Permit Number: FL0000051 (major)
File Number: FL0000051-015-IW3S
Bradford County
Chemours-Trail Ridge Plant

NOTICE OF INTENT TO ISSUE PERMIT

**AMENDMENT TO FACT SHEET
FOR
STATE OF FLORIDA INDUSTRIAL WASTEWATER FACILITY PERMIT**

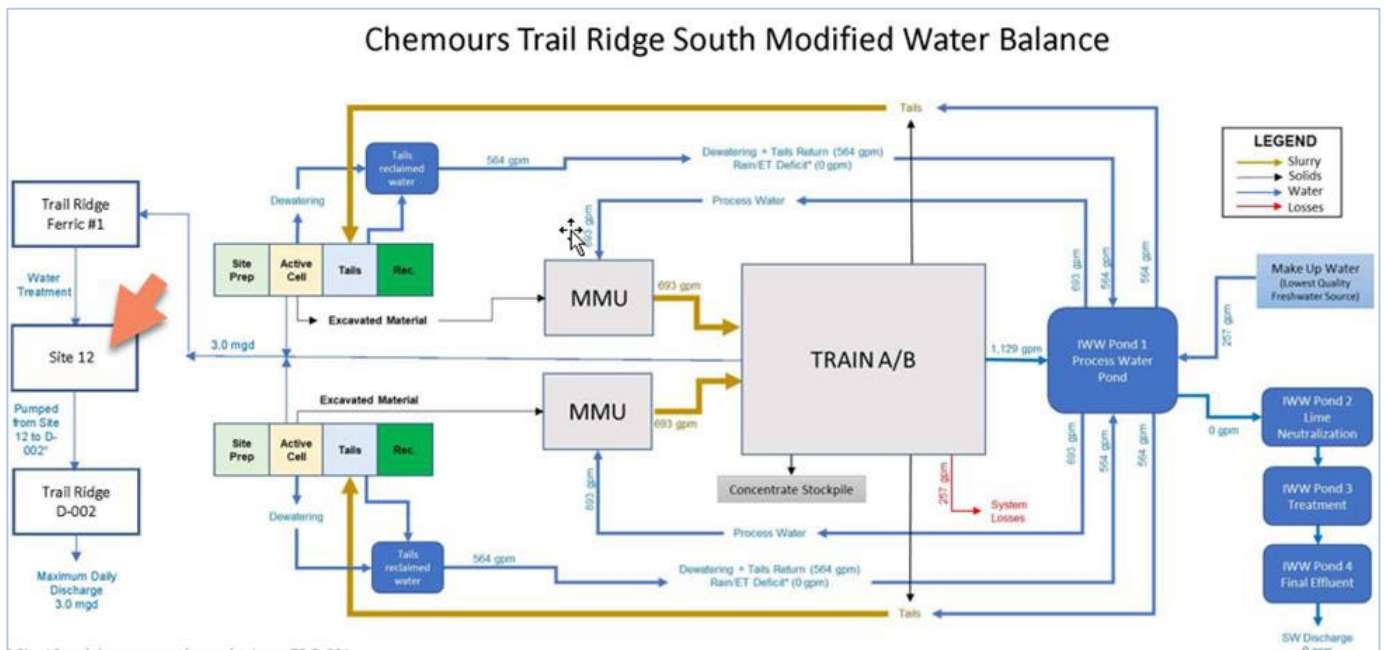
Water from the Trail Ridge South Mine should be monitored either at the point it is withdrawn or the point it enters the Florida Mine-Trail Ridge IWW. *B. Surface*

Water Discharges (Outfall D-002) (Temporary) could be written to make it apply to the water from the Trail Ridge South Mine.

If B.1. is deleted all of B. would also be deleted.

DEP Response: Trail Ridge South has an approved outfall at D-001 to Double Run tributary. This is the preferred discharge outfall, as transfer to Trail Ridge requires active pumping.

Figure 2: Water Balance Map:

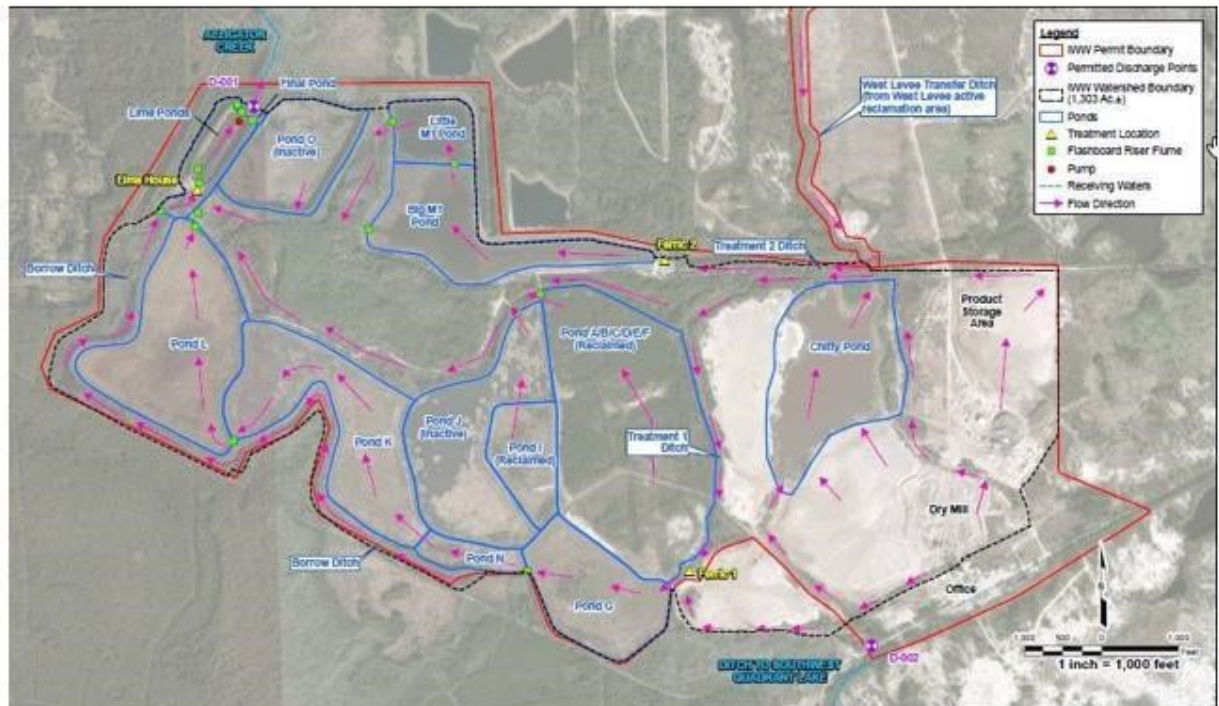
The IWW Permit Boundary in red should be expanded to the Chemours Bradford County property lines on the west and south of the ponds. The current location of the pump (red dot) needs to be verified.

Please find updated the Water Balance and Process Flow Diagram, which will include in the Fact Sheet:

Figure 3: Process Flow Diagram

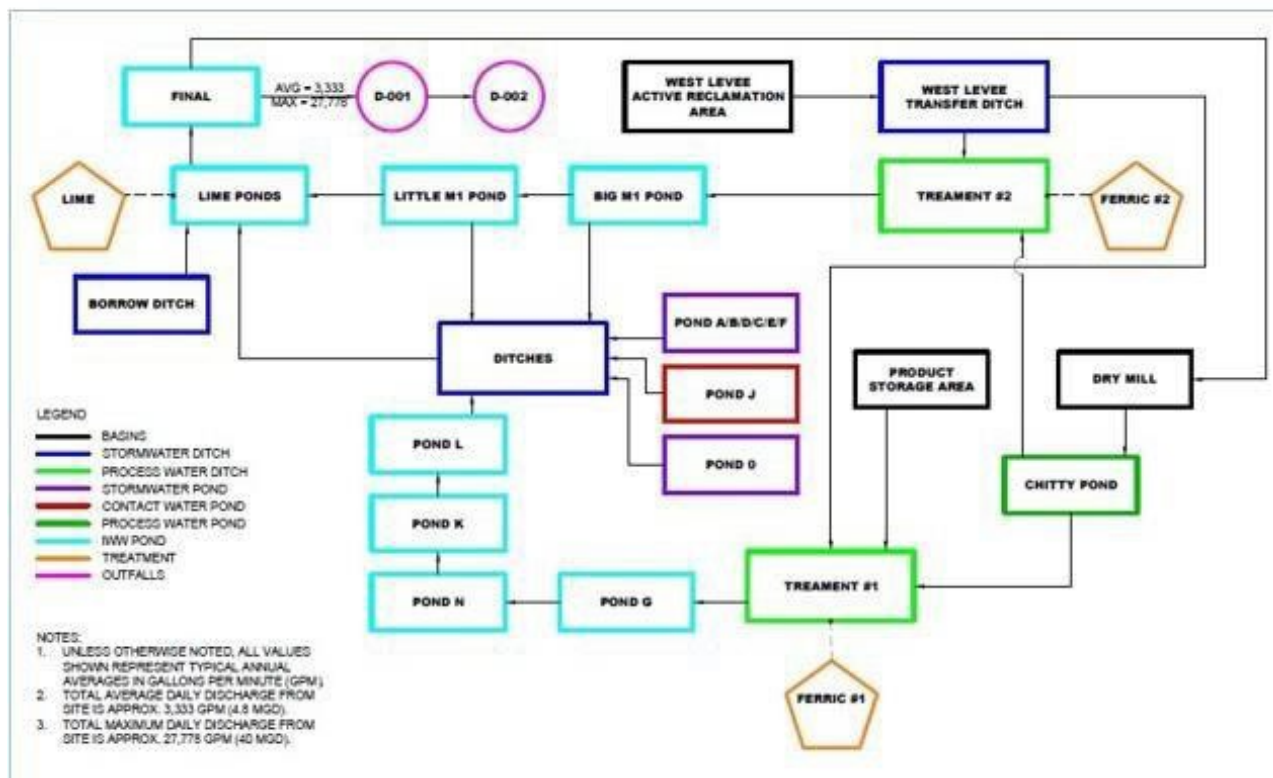
The Process Flow Diagram does not show offsite flows from the Borrow Ditch (dark blue box upper left) to the south west under and over the railroad tracks and onto adjacent property owned by the NFLT. The flow of water with high iron content from the eastern part of the Borrow Ditch appears to be impacting wetlands on the NFLT property to the south of the Chemours and railroad properties. After water flows from the central portion of the Borrow Pit it flows over and under the railroad onto the NFLT property. It then flows west and then north to pass under the railroad and enter a drainage system that flows to Alligator Creek between Bradford Court and Country Club Estates. At times the water flowing offsite has had levels of iron that exceeded the 1 mg/L limit for iron levels. Samples of water from the drainage feature that carries water to Alligator Creek also have had iron levels above the 1 mg/L limit.

Trail Ridge Flow Schematic

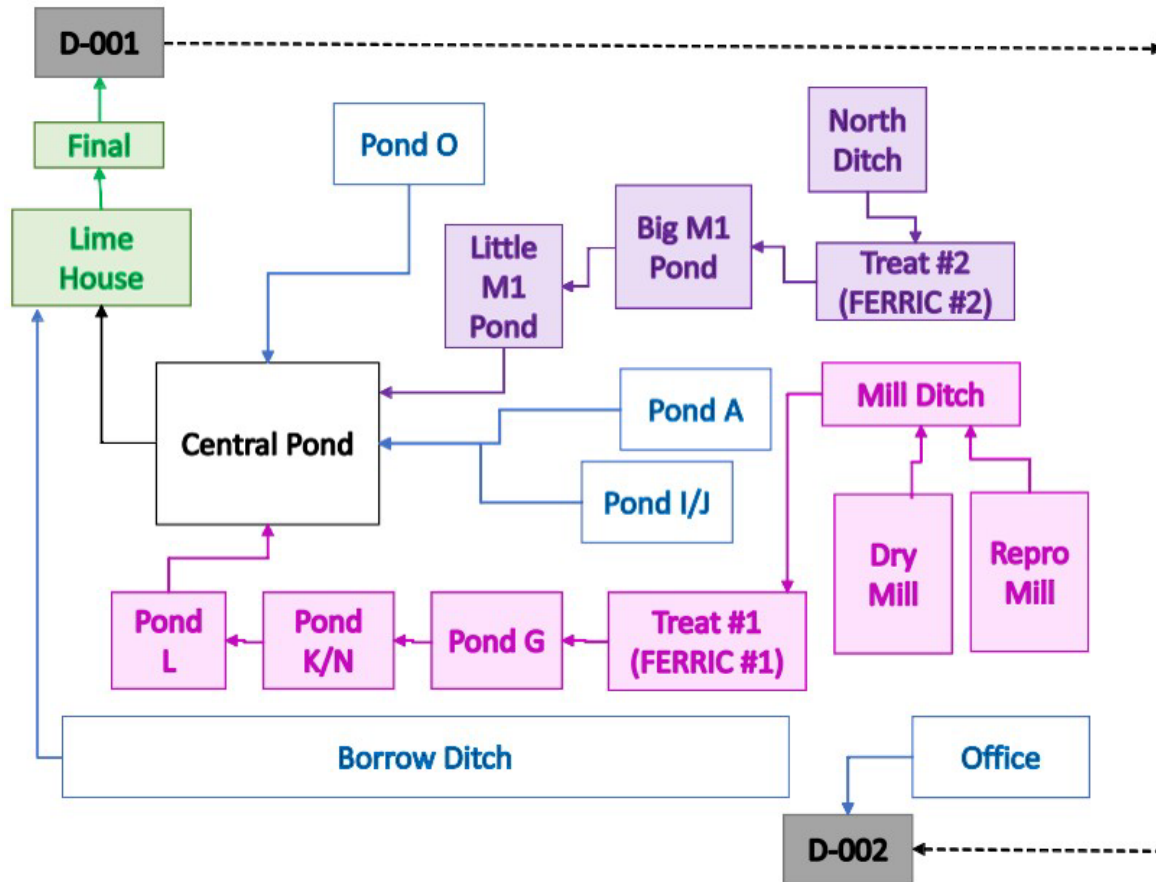
In the above the black dotted line from D-001 to D-002 should start after “Final” not D-001.

Response: While the Department agrees with the above statement, the schematic shown above does not depict a significant change in water quality. Schematics in Appendix B depict the flow of the effluent.

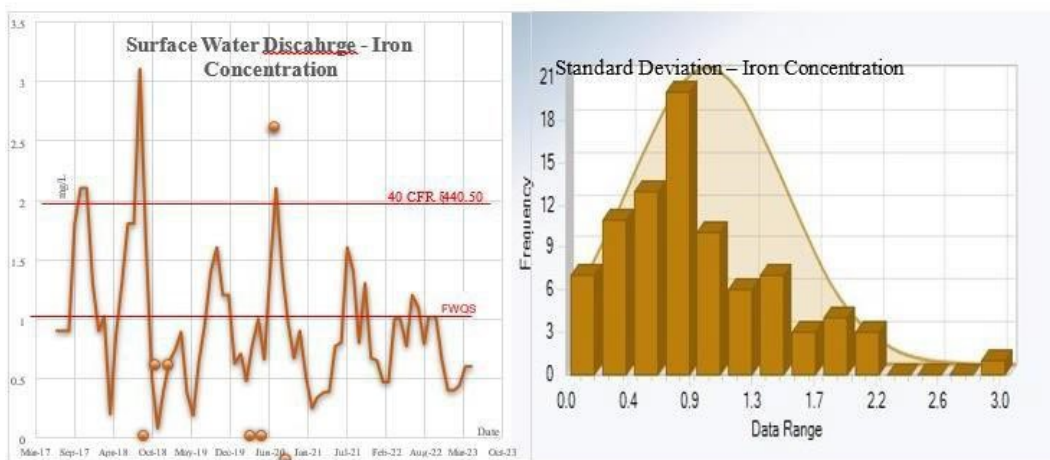
(Correct spelling of Discharge in the graph on the left.)

Figure 2: Water Balance Map:

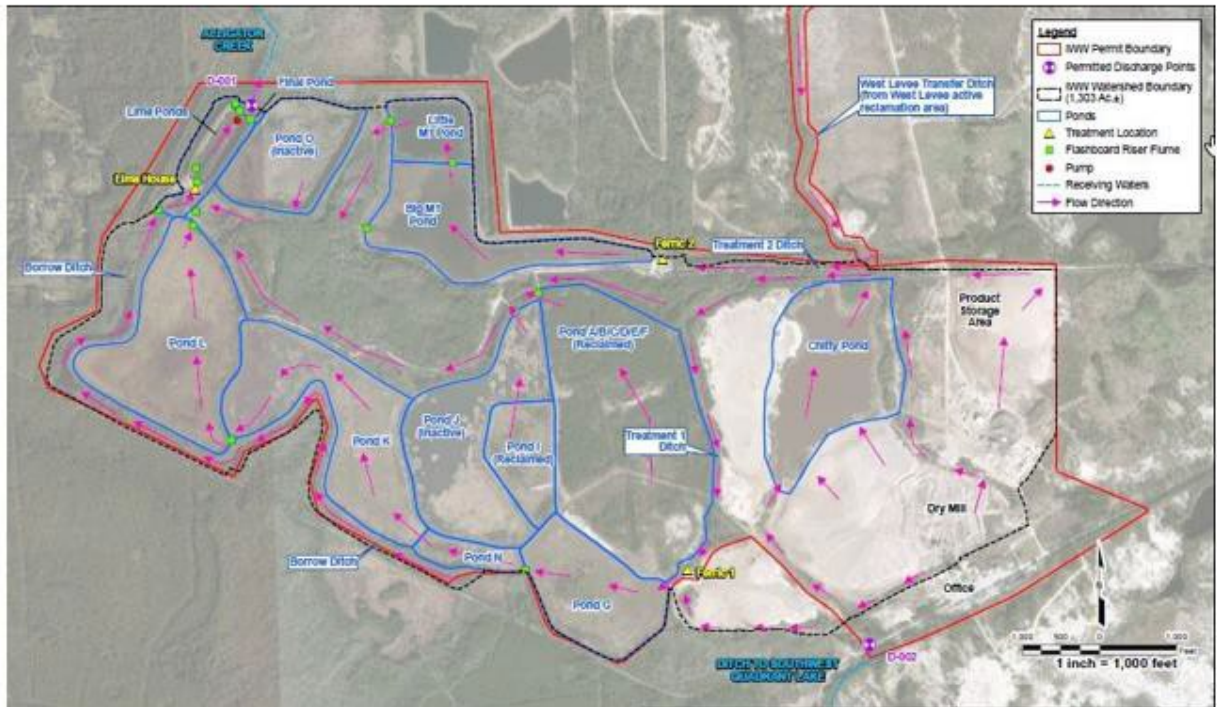
The IWW Permit Boundary in red should be expanded to the Chemours Bradford County property lines on the west and south of the ponds. The current location of the pump (red dot) needs to be verified.

Please find updated the Water Balance and Process Flow Diagram, which will include in the Fact Sheet:

Figure 3: Process Flow Diagram

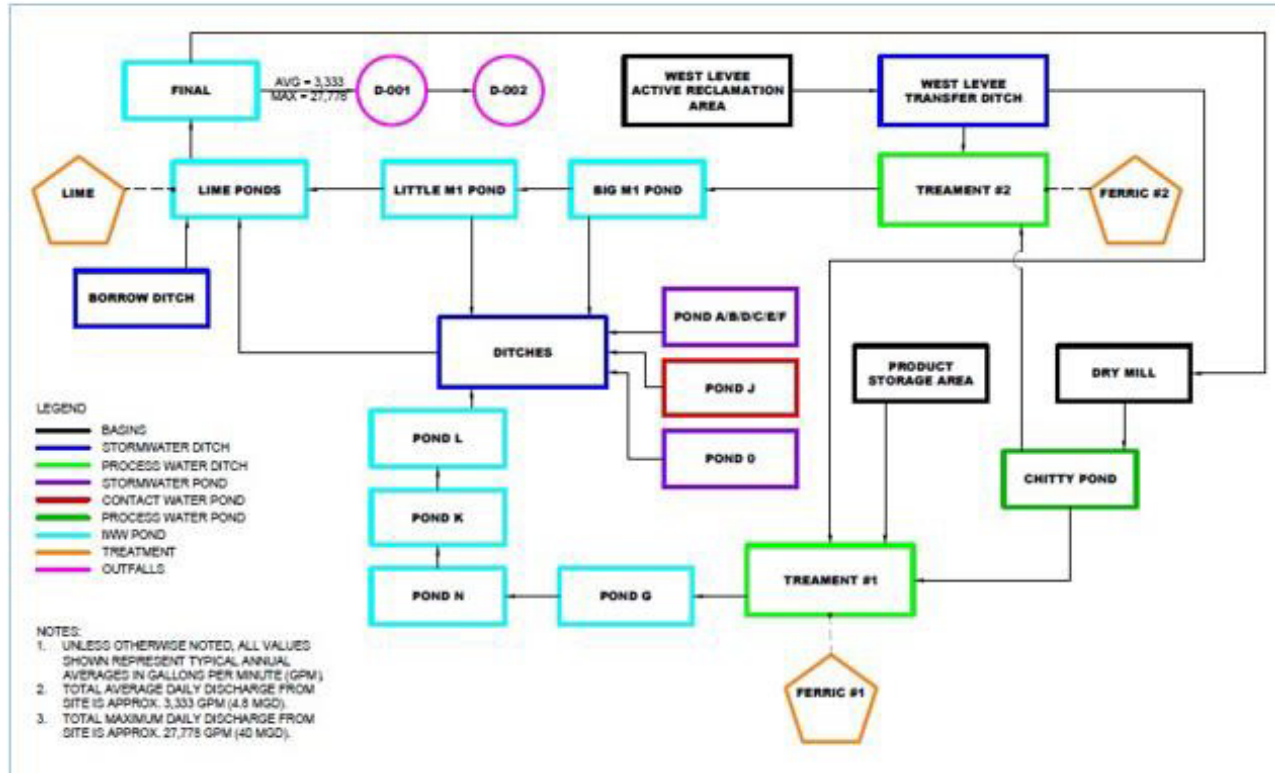
The Process Flow Diagram does not show offsite flows from the Borrow Ditch (dark blue box upper left) to the south west under and over the railroad tracks and onto adjacent property owned by the NFLT. The flow of water with high iron content from the eastern part of the Borrow Ditch appears to be impacting wetlands on the NFLT property to the south of the Chemours and railroad properties. After water flows from the central portion of the Borrow Pit it flows over and under the railroad onto the NFLT property. It then flows west and then north to pass under the railroad and enter a drainage system that flows to Alligator Creek between Bradford Court and Country Club Estates. At times the water flowing offsite has had levels of iron that exceeded the 1 mg/L limit for iron levels. Samples of water from the drainage feature that carries water to Alligator Creek also have had iron levels above the 1 mg/L limit.
